ADDENDUM NO. 2

23 January 2017

RE: MILLER PARK DISTRICT PHASE 1
Contract no. R-14-011-201

FROM: Spackman Mossop Michaels / Eskew+Dumez+Ripple, Joint Venture
365 Canal Street, Suite 3150
New Orleans, Louisiana 70130
(504) 561-8686

Sheet No: C101

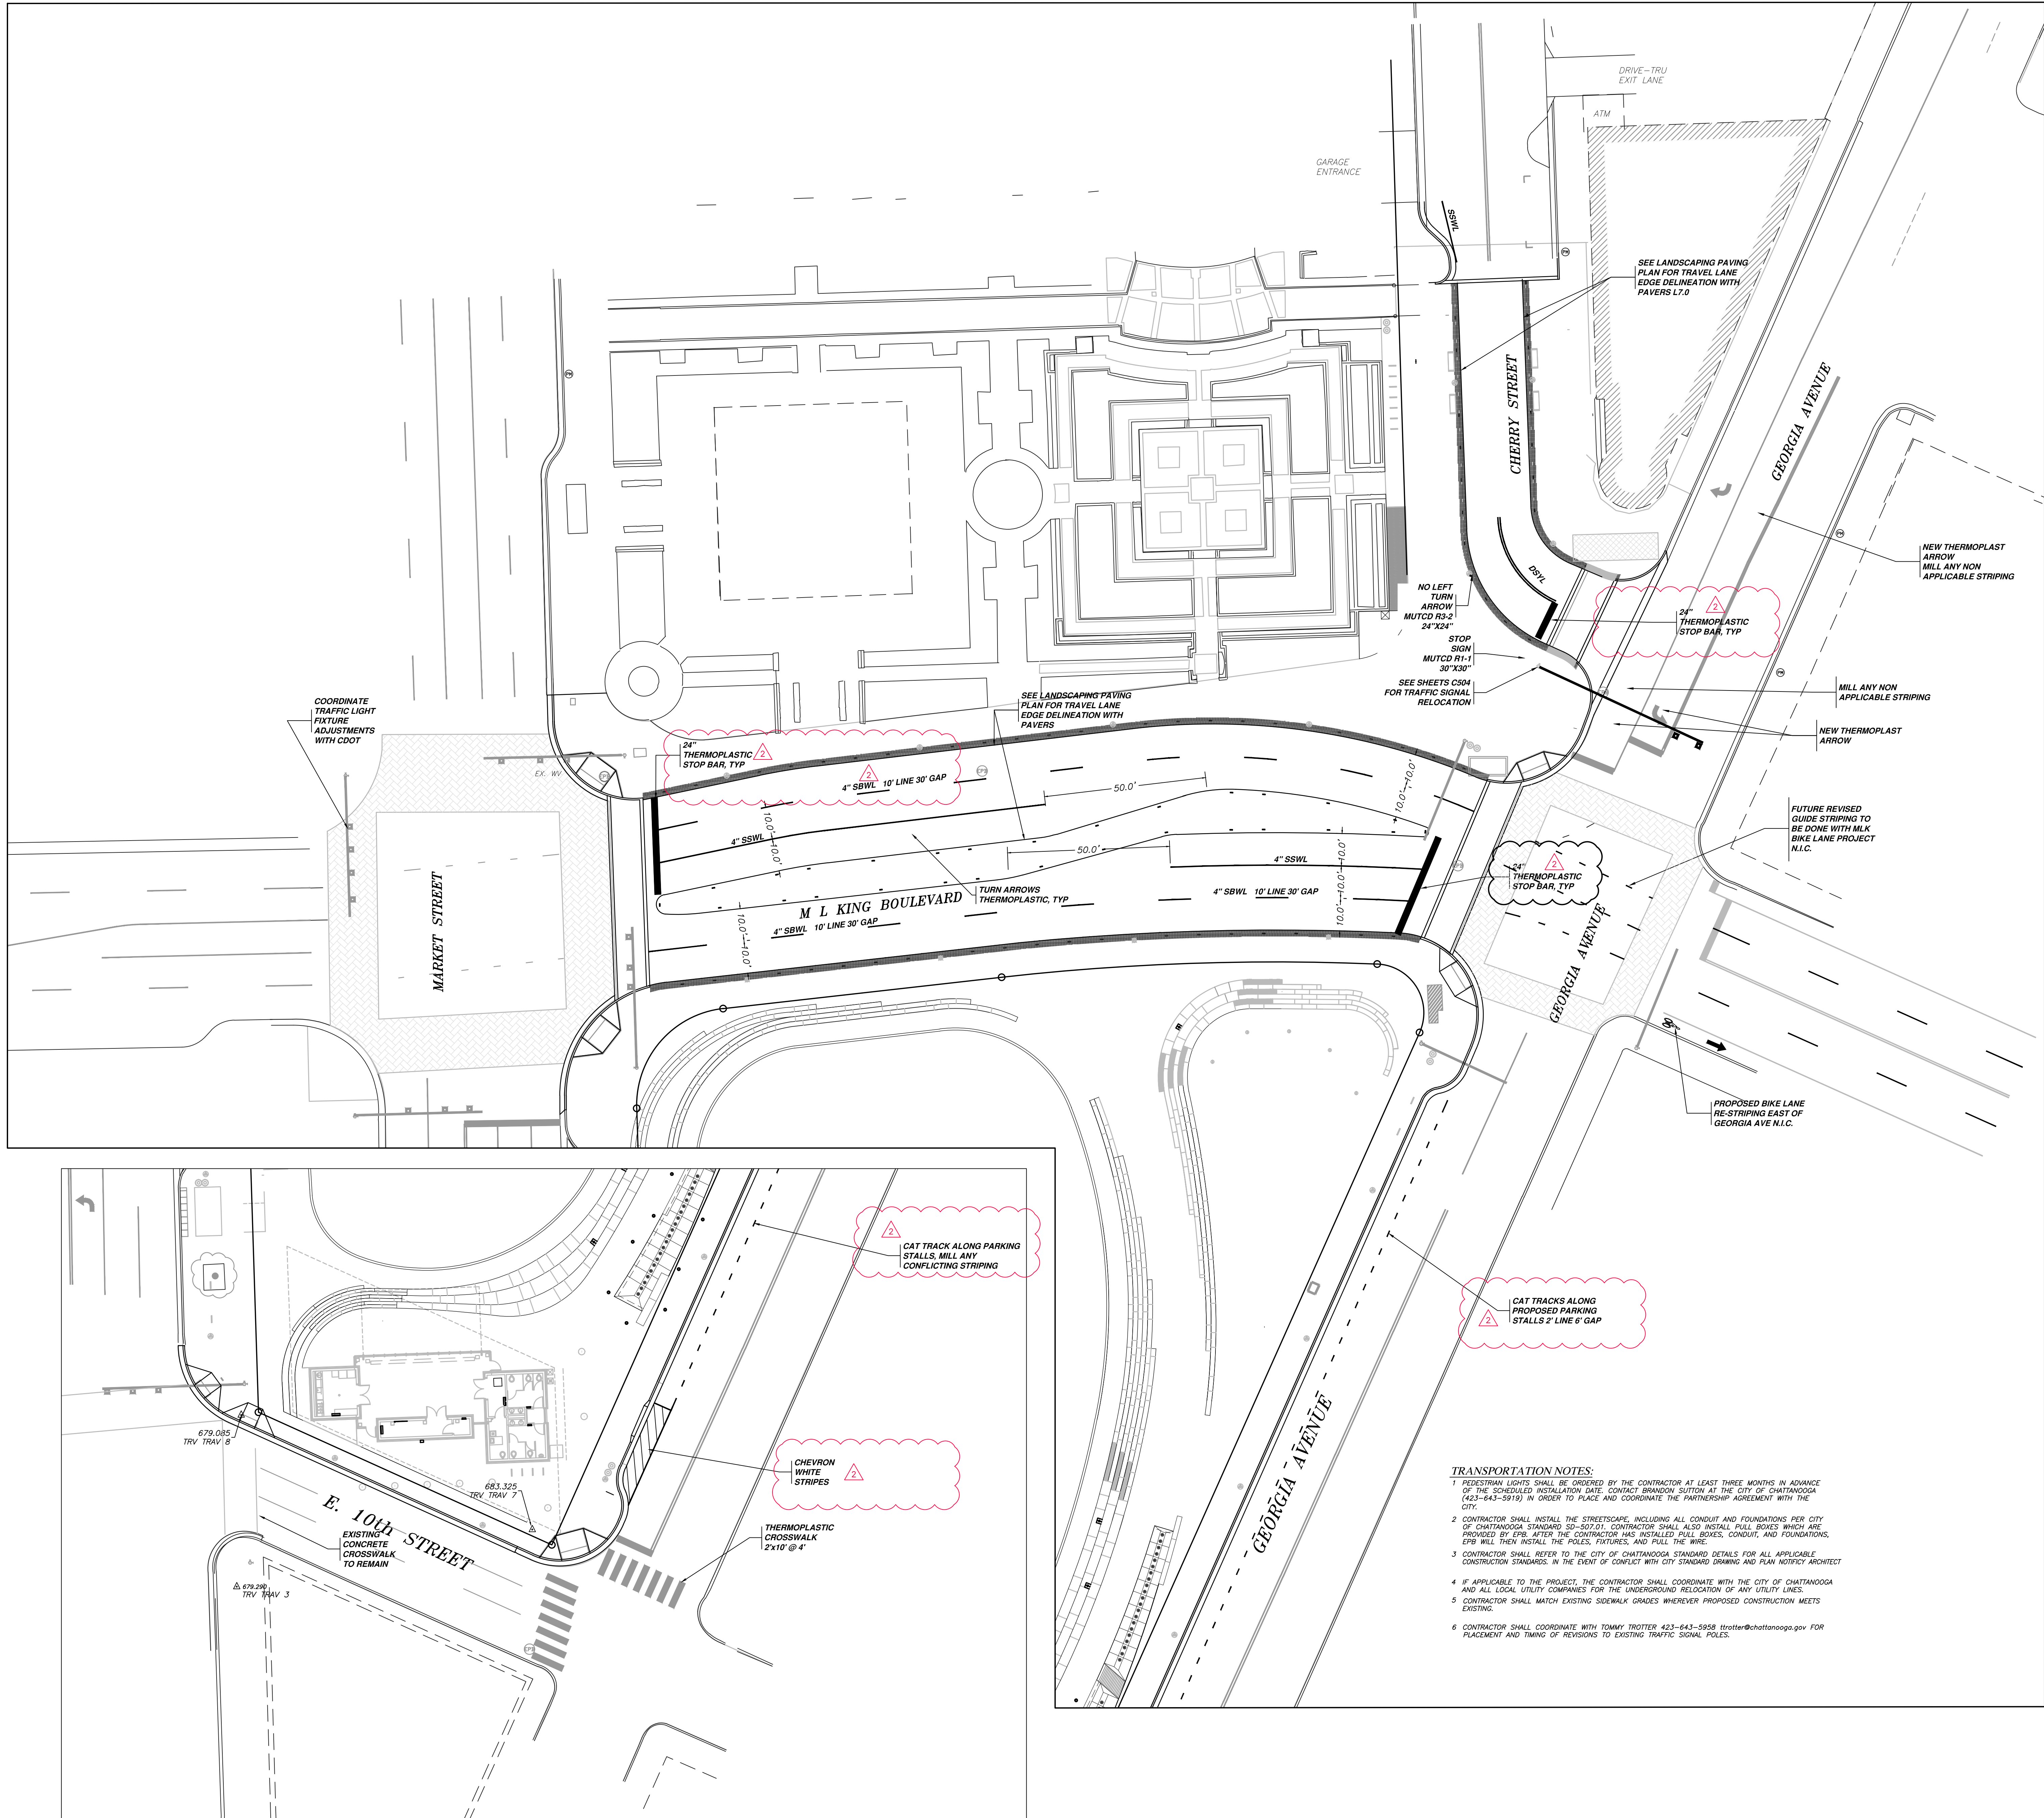
5. The following Drawings Sheet(s) are hereby replaced as part of this Addendum, attached herein:
 - A. C101, Revised curb ramp geometry and striping where clouded.

Sheet No: **C701**

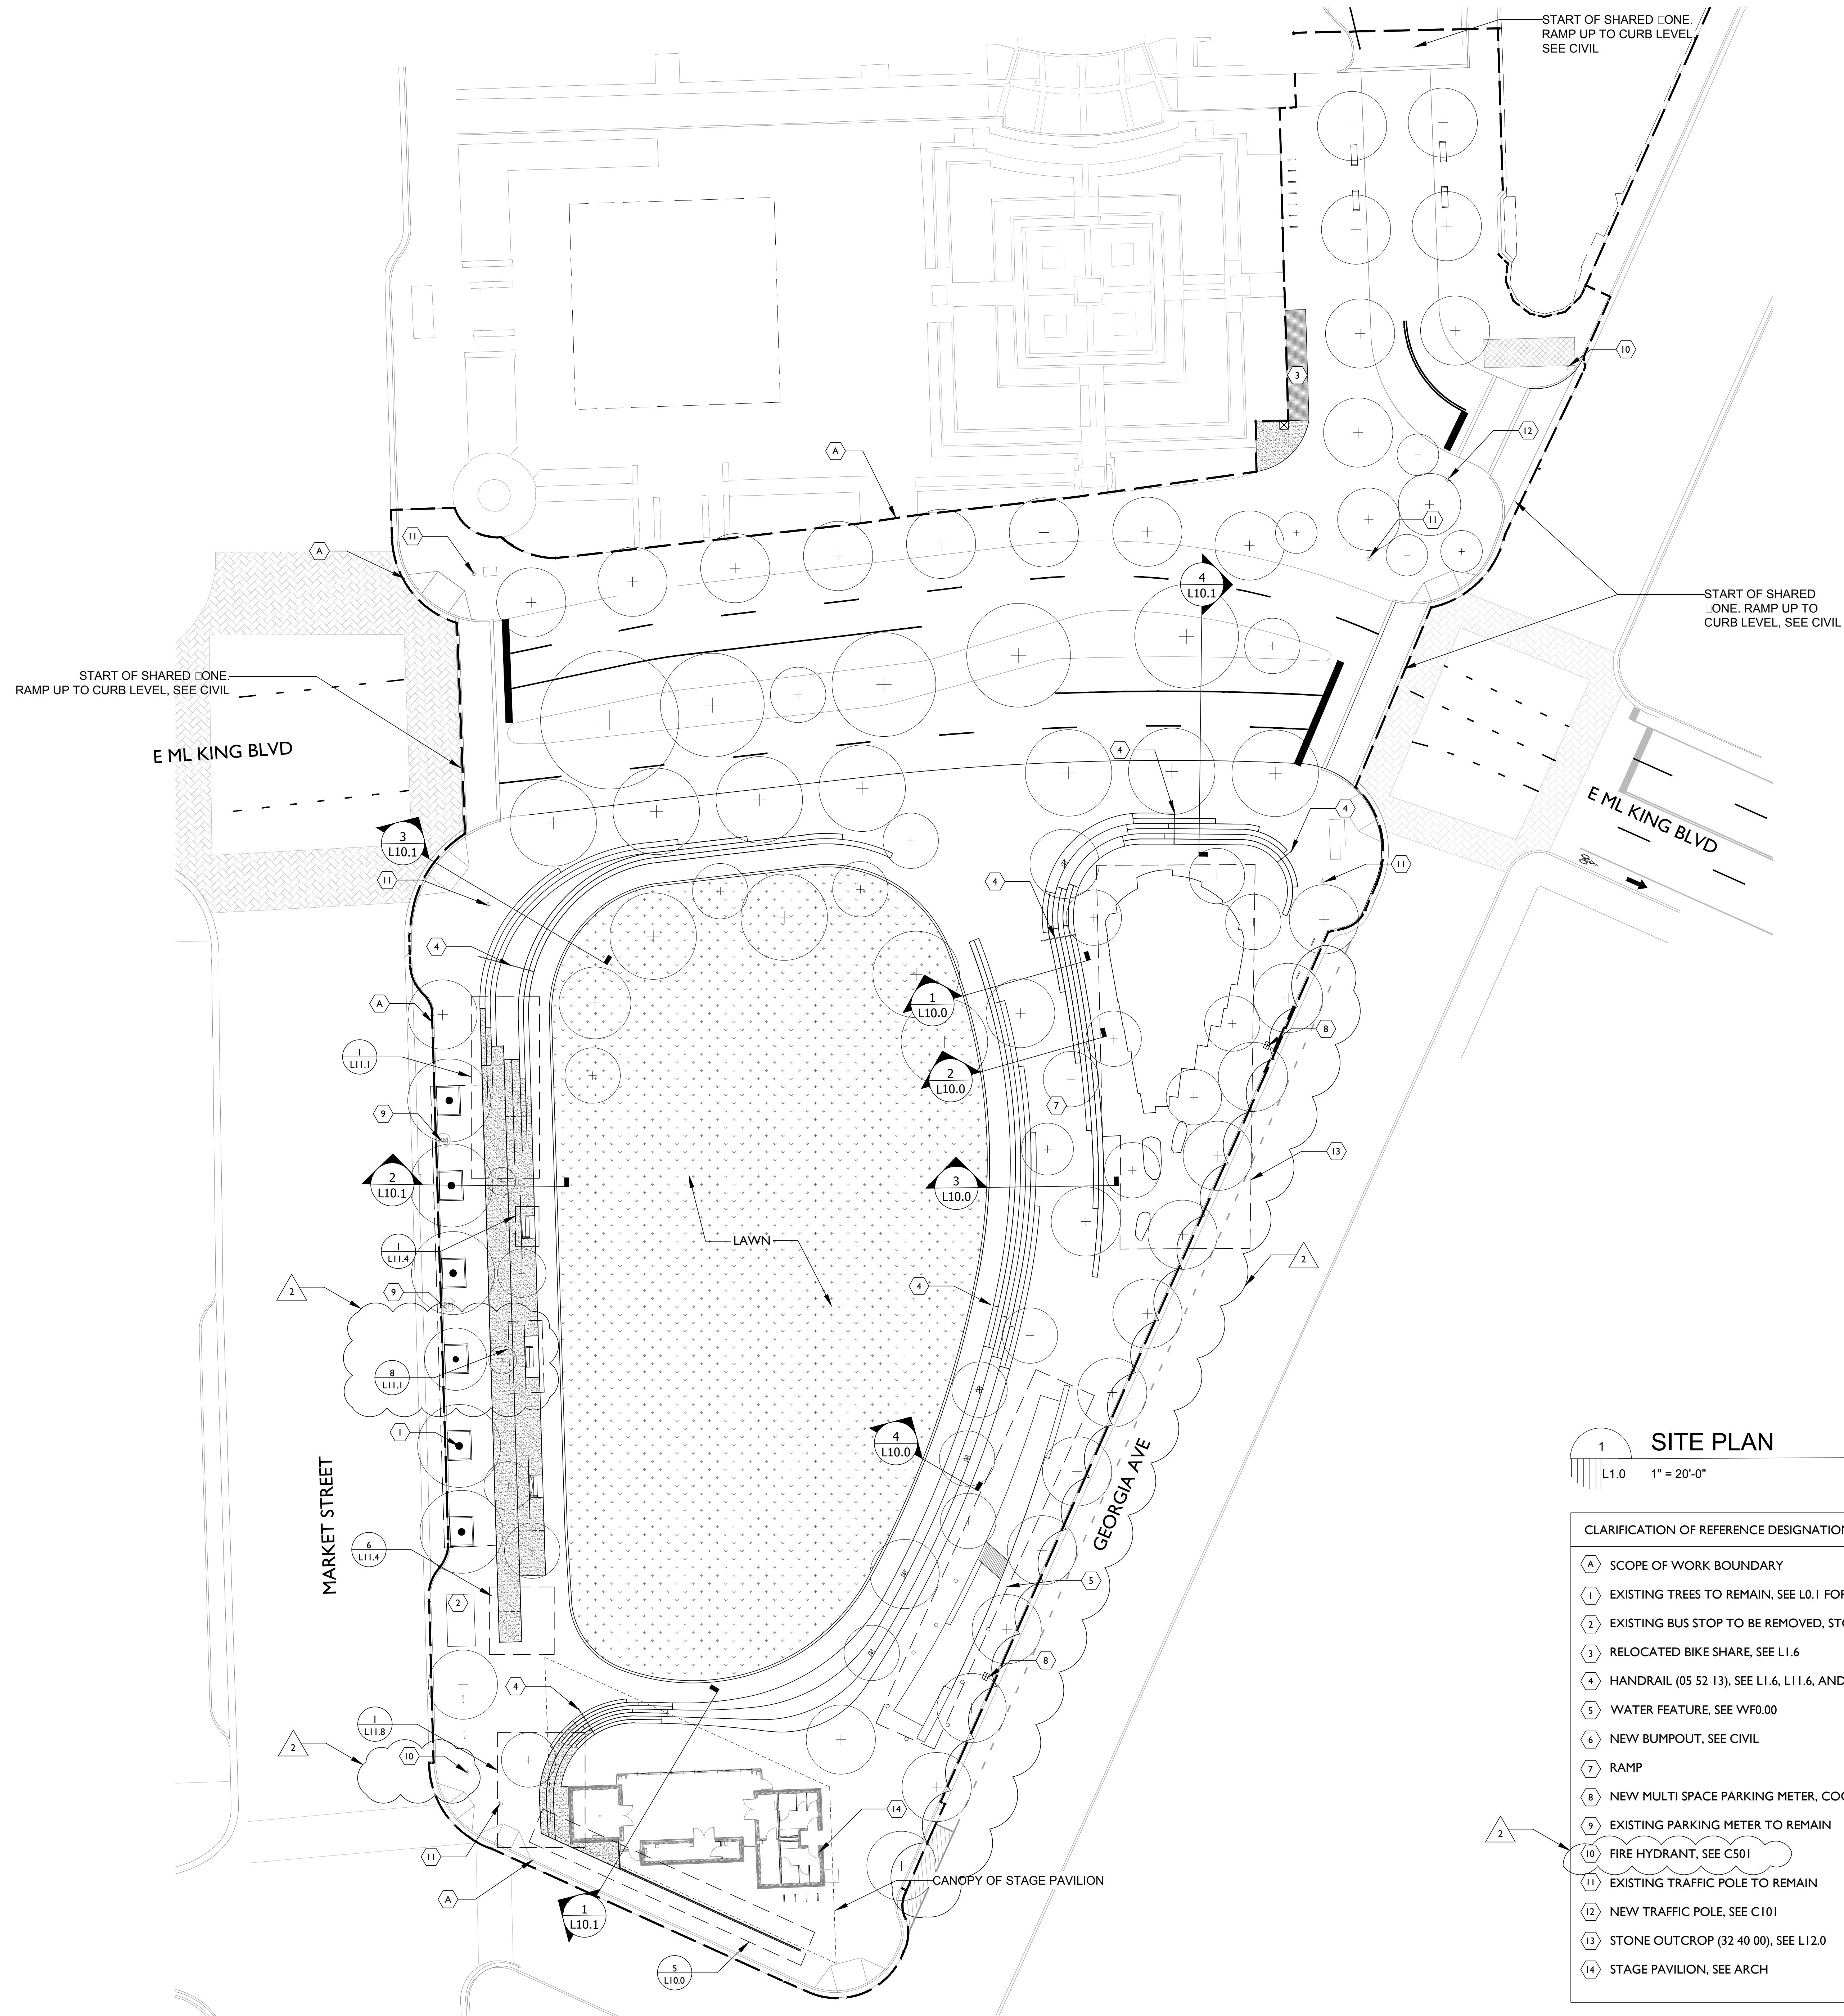
4. The following Section(s) have not previously been issued and are introduced as Procurement Documents as part this Addendum, attached herein:
 - A. C701 This sheet was added to show traffic control for the bid Alt#1, which closed MLK Blvd

L1.1

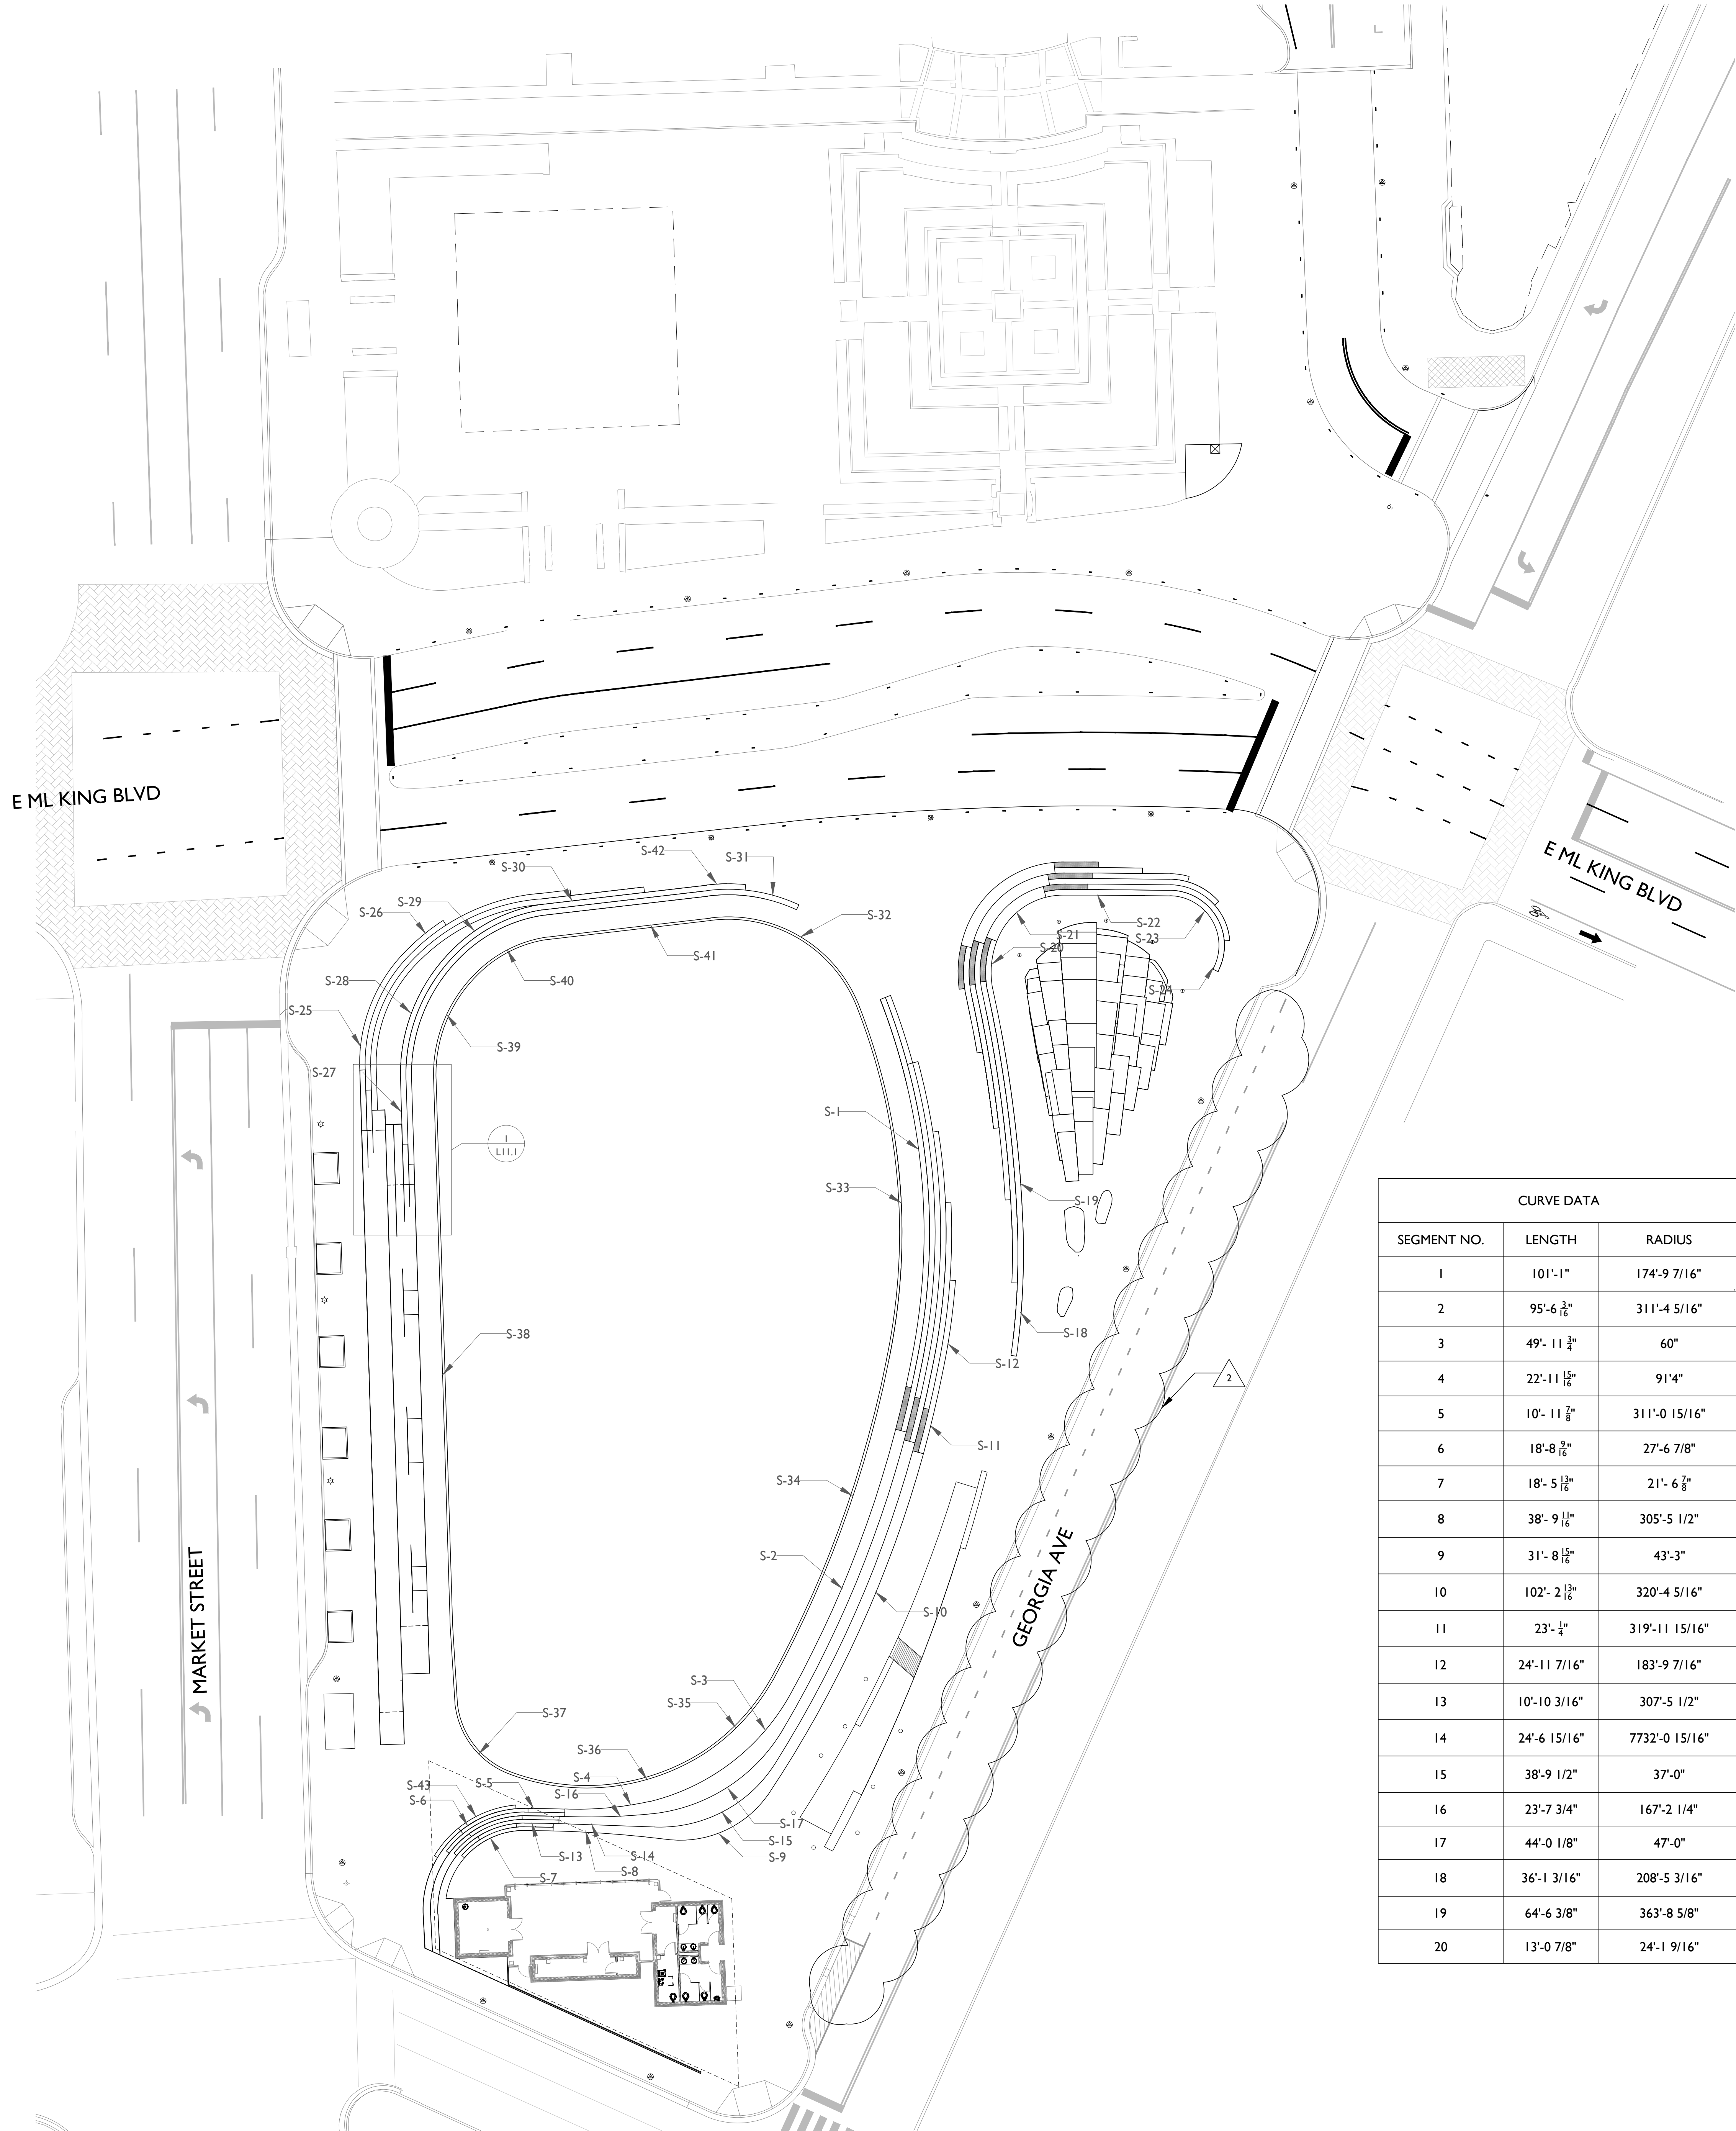
- J. L1.1- SITE LAYOUT PLAN: Adjusted dimensions for garden terrace along Market St. Removed parking space striping on all LA plans along Georgia Ave. Please see C103 for Roadway and Striping Plan.
